CMA PRODUCT IMPROVEMENT

Effective Date: MAY 2016
Log Number: CMA-PI-469
Subject: DISH RACK SUPPORT BAR
Model Affected: EST-66

Dish Rack Support Bar

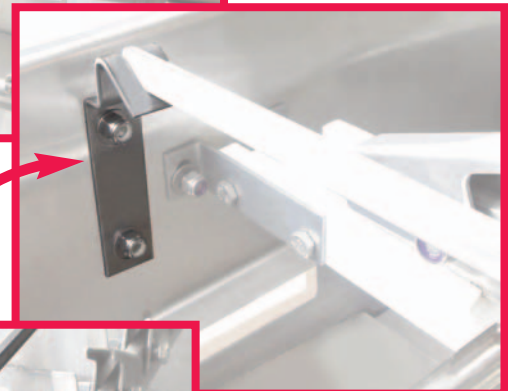
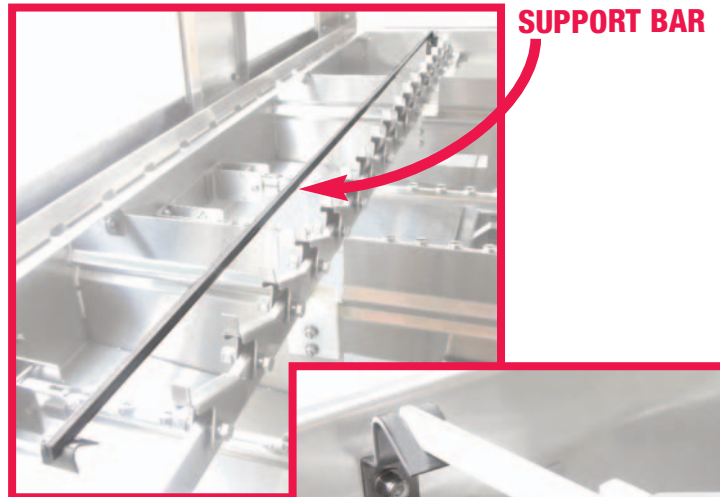
This CMA Product Improvement ensures smooth operation of our EST-66 conveyors when washing heavy cast iron Fajita and steak serving platters or thick, heavy china plates. The Dish Rack Support Bar prevents the plastic dish racks from bowing and flexing under heavy weight conditions, causing the jamming of the conveyor dogs and impeding the movement of the dish rack through the conveyor. The retro-fit kit is P/N: 13906.50 and comes with templates for drilling and notching the mounting holes and slots.
